ARCHITECTURAL ADVISORY COMMITTEE

DATE: January 9, 2024

APPLICANT: 901 Ethan Allen Hwy

Nuvance Health

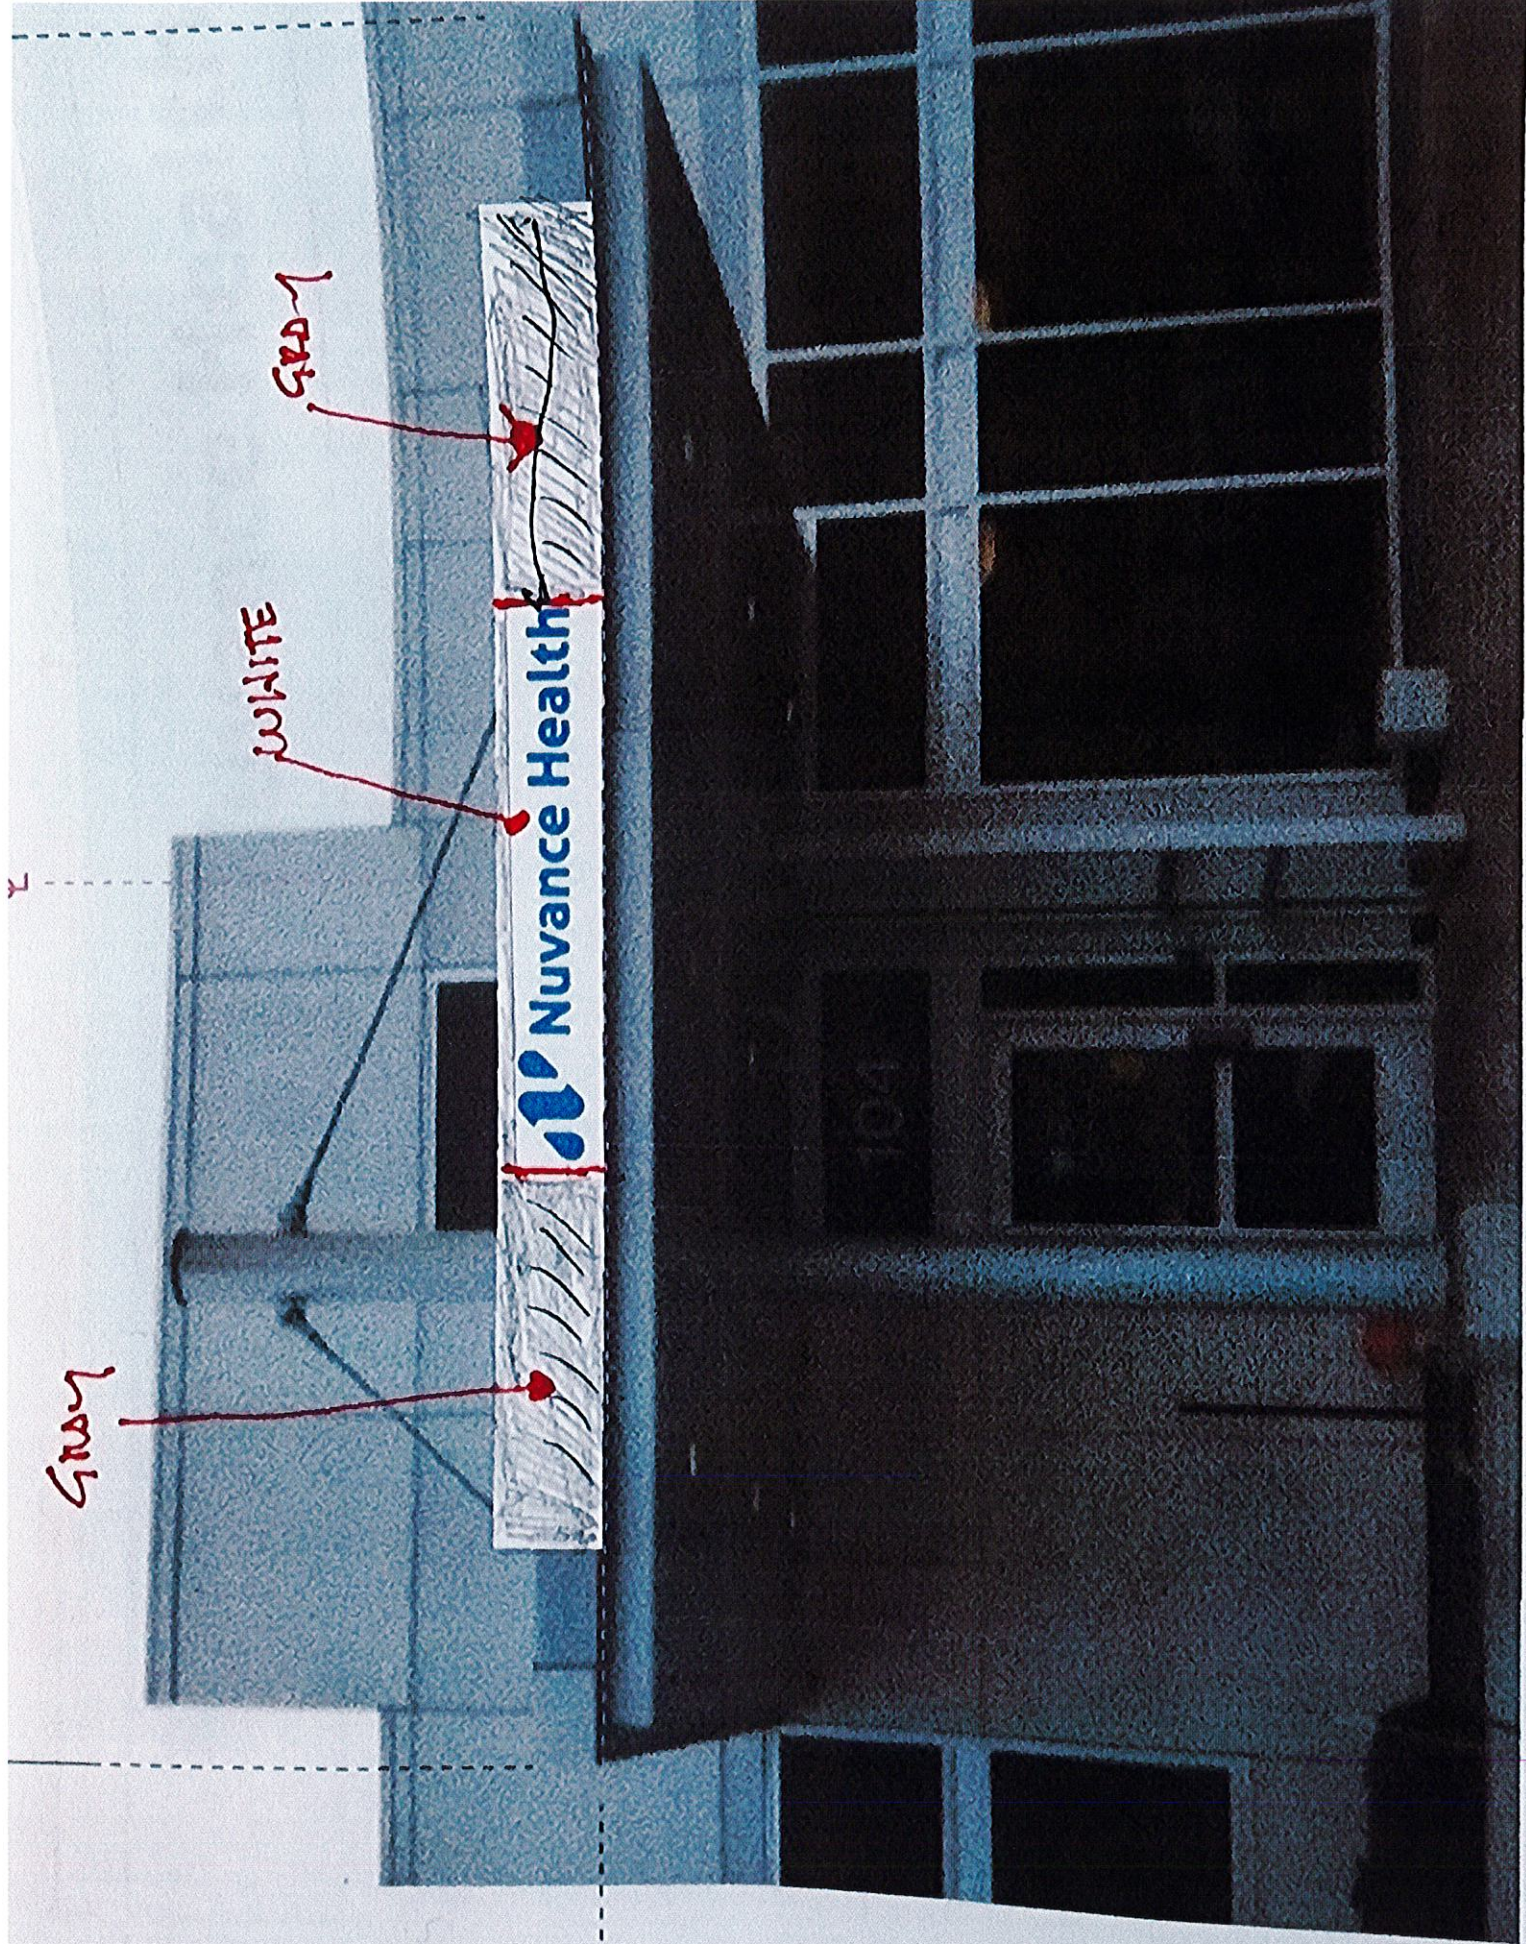
The AAC recommends approval of the submitted signs with the exception of the proposed sign replacing the 'Danbury Hospital Diagnostic Imaging' sign. The white area of the proposed sign should just be at the symbol and lettering. (*see photo*)
